☒ Oil Well ☐ Gas Well ☐ Other8. Well Name and No.  
AUODAD FEDERAL 22. Name of Operator  
RKI EXPLORATION & PROD LLCContact: CRYSTAL FULTON  
E-Mail: crystal.fulton@wpenergy.com9. API Well No.  
30-015-28554-00-S13a. Address  
3500 ONE WILLIAMS CENTER MD 35  
TULSA, OK 741723b. Phone No. (include area code)  
Ph: 539-573-021810. Field and Pool or Exploratory Area  
HAPPY VALLEY

Please be advised RKI Exploration requests approval to P&A the above well. The WBD and Plan are attached.

## Auodad Fed #2 Plug and Abandon Procedure

**Permanent Abandonment of Federal Wells  
Conditions of Approval**

**Auodad Fed #2  
Proposed WB**

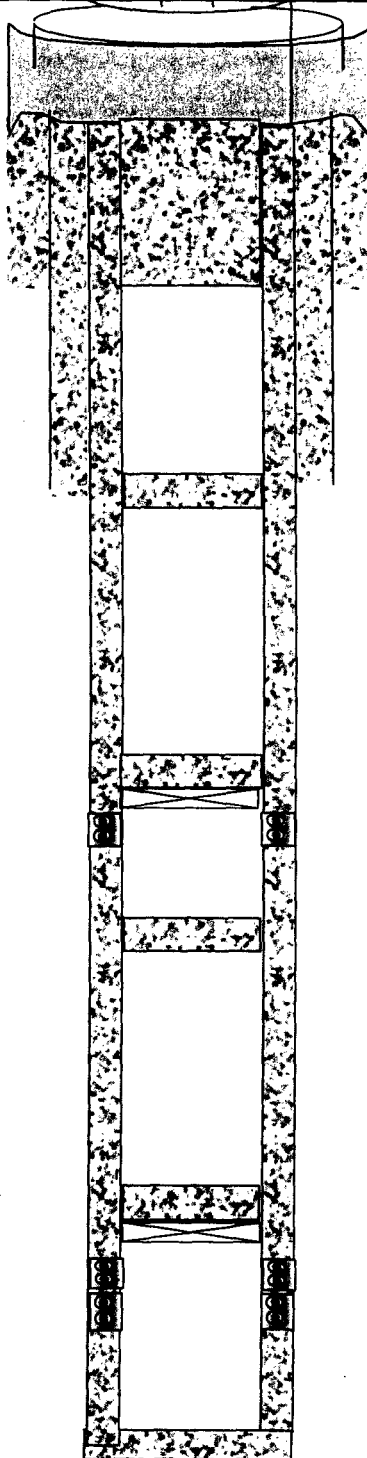
Spot 45 sxs . from 400' to Surface

Spot 25 sxs 1725' - 1475' WOC & Tag

Set CIBP @ 2400' & spot 25 sxs to 2150'

Spot 25 sxs from 3400 - 3150'

RIH & Tag CIBP & spot 25 sxs on top to 4400'
